TOWN OF SEABROOK ISLAND

Planning Commission Regular Meeting

1. Encroachment Permit Request: Kiawah Senior Living Facility [Pages 7–168]

TO: Planning Commission Members
FROM: Joseph M. Cronin, Town Administrator
SUBJECT: Encroachment Permit Application for Kiawah Senior Living Project
MEETING DATE: October 3, 2018

STAKING AND SIGNAGE PLAN

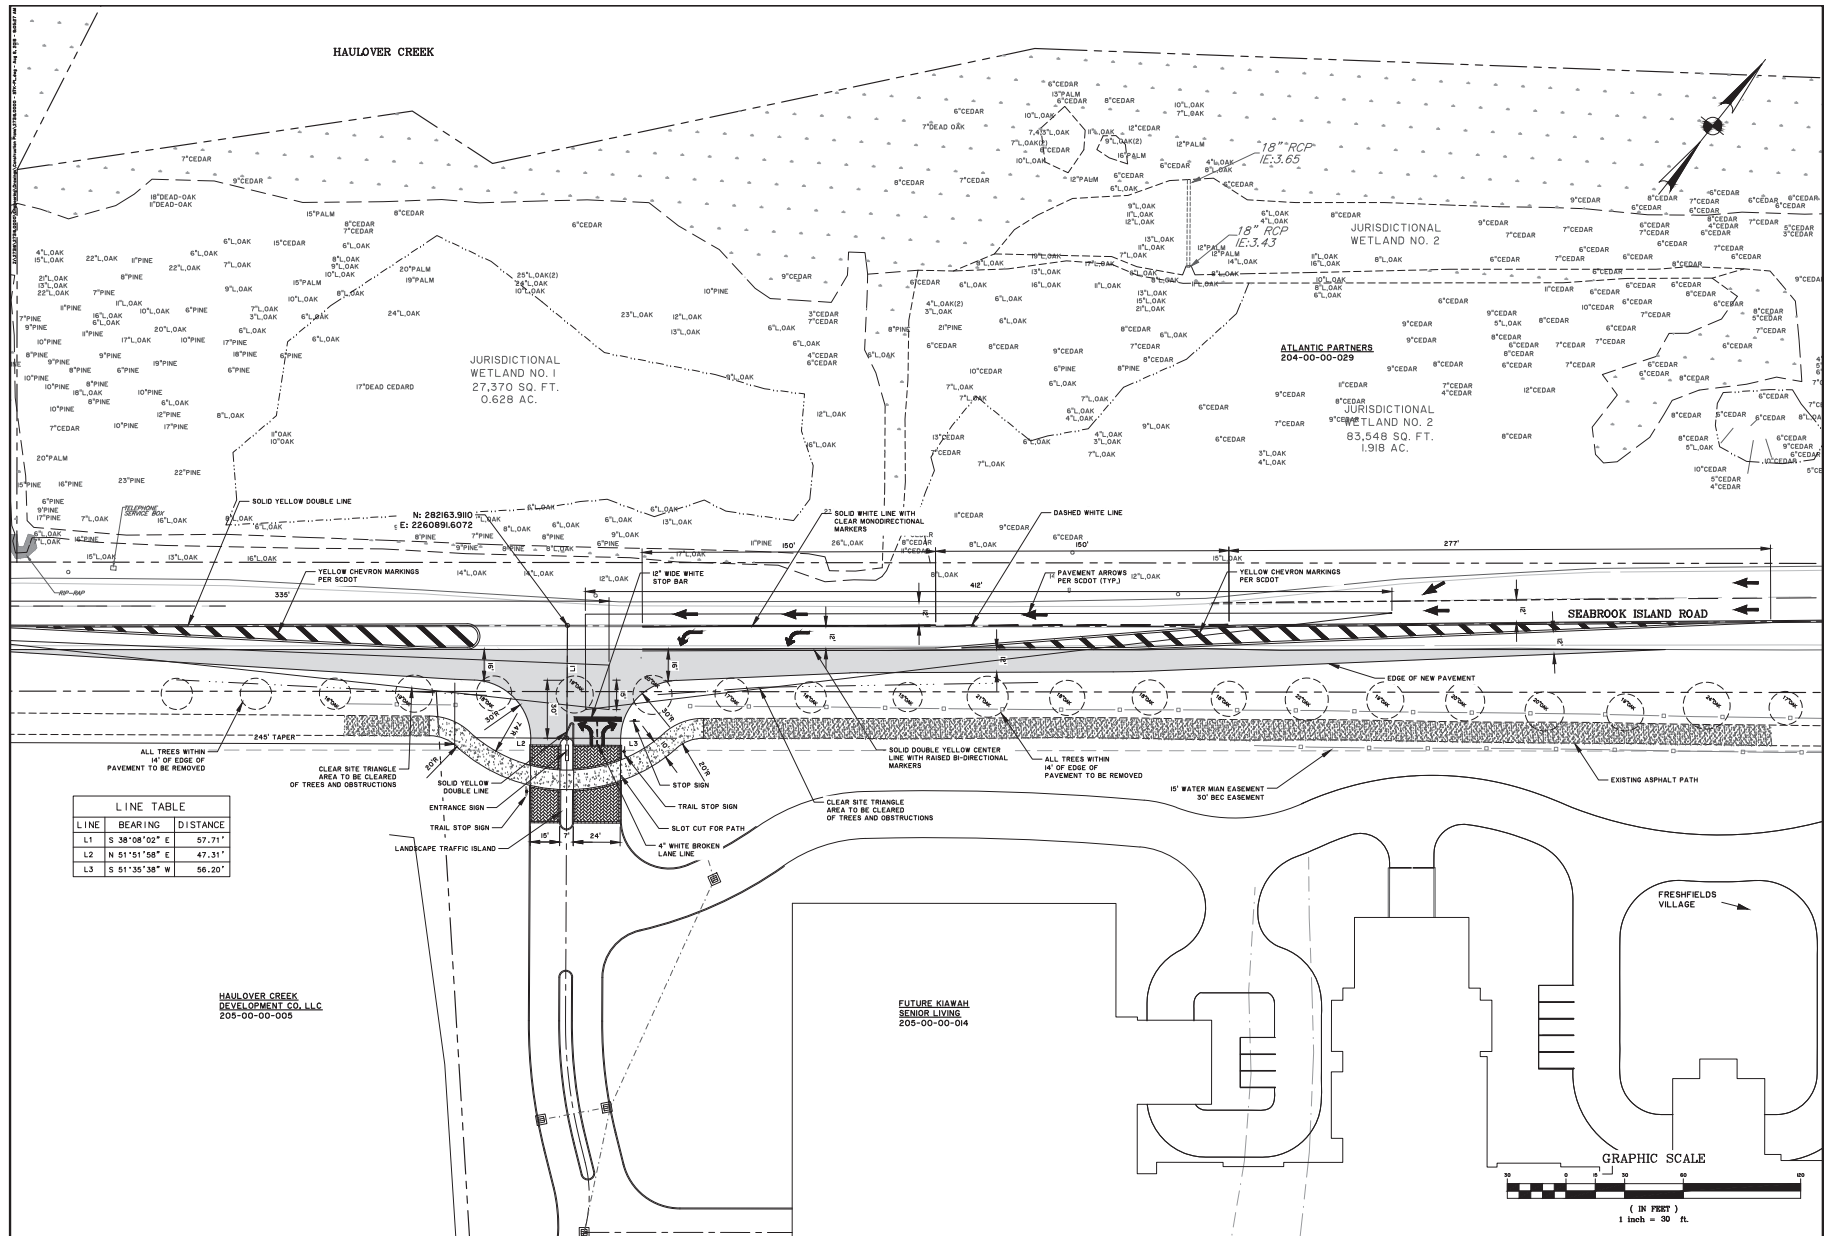
Following their presentation to the Planning Commission on July 18th, the applicants revised their plans to include the addition of a left turn lane from Seabrook Island Road into the property. The plans for the pedestrian pathway was also modified to improve visibility and pedestrian safety. Lastly, the interior road configuration at the main driveway was modified to address safety concerns identified by town staff.

- The multi-use path was revised to maintain a 10' width, rather than decreasing from 10' to 8' across the proposed driveway. *(Acceptable per Reveer Group)*

- The transition from the existing pathway to the "arc" across the new driveway was modified to be less abrupt. *(Acceptable per Reveer Group)*

**Atlantic Partners
Tree Impact Plan**

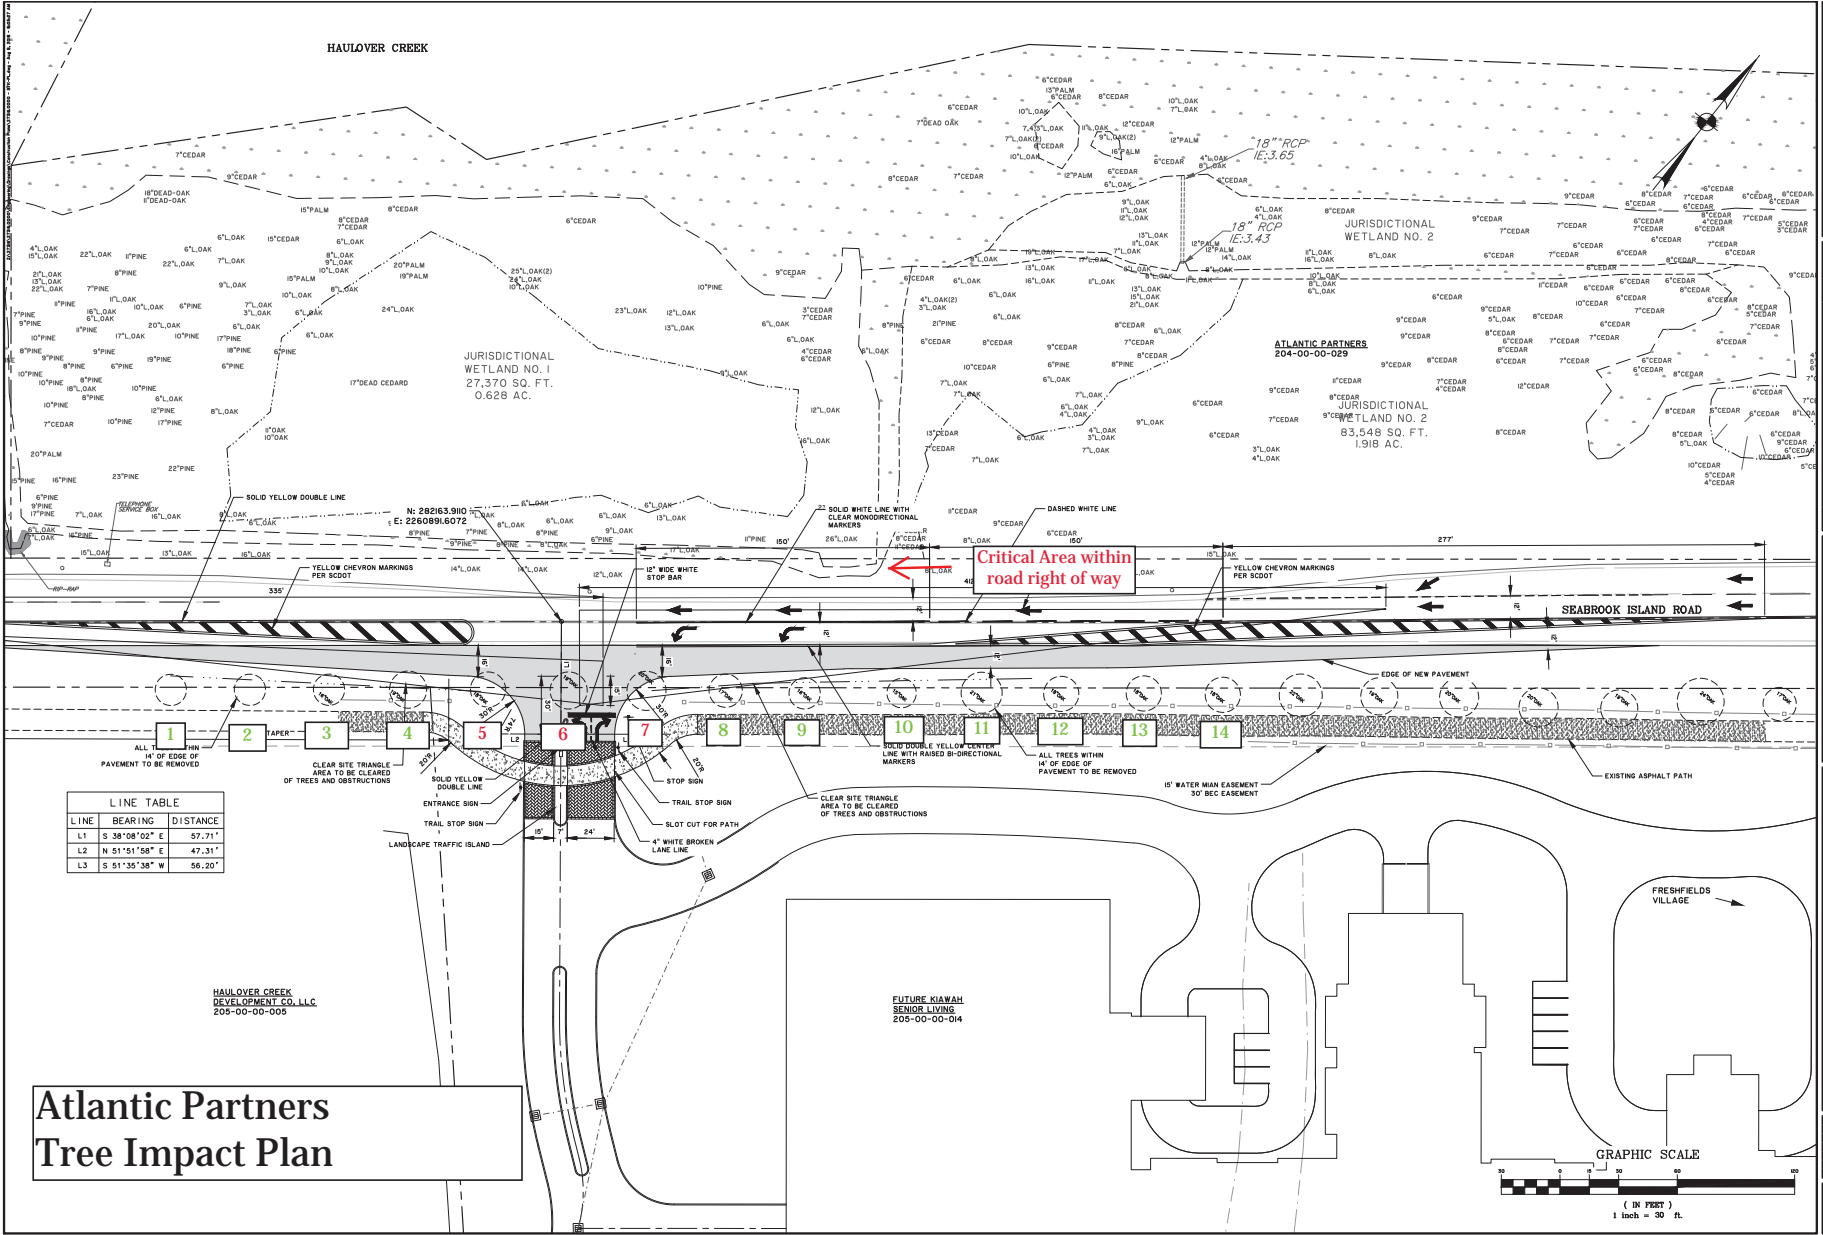
- Removal of three trees (Trees 5-7 on Tree Exhibit).
 - Note: The Tree Impact Statement provided justification for not removing additional trees, as this would be contrary to the spirit of the Town of Seabrook Island's tree preservation ordinance, Kiawah Island's buffer requirement, Charleston County's Zoning and Land Development Regulations, and precedent set by the proximity of trees along nearby roads. *(The Reveer Group noted that this was a valid justification and rescinded its earlier comment to the contrary.)*

Also noted in the Reveer report is reference to the provisioning of providing a 14-foot clearance from the edge of the roadway from any trees based on Table 9-18 of SCDOT's *Access and Roadside Management Standards* (attached). The Reveer report noted that application of this criteria would require the removal of a total of twelve live oak trees. However, attached Tree Impact Plan shows that strict adherence to this criterion as based on the updated design will now require the removal of *fourteen* live oak trees given the lengthening of the turn lane and taper recommended in the report.
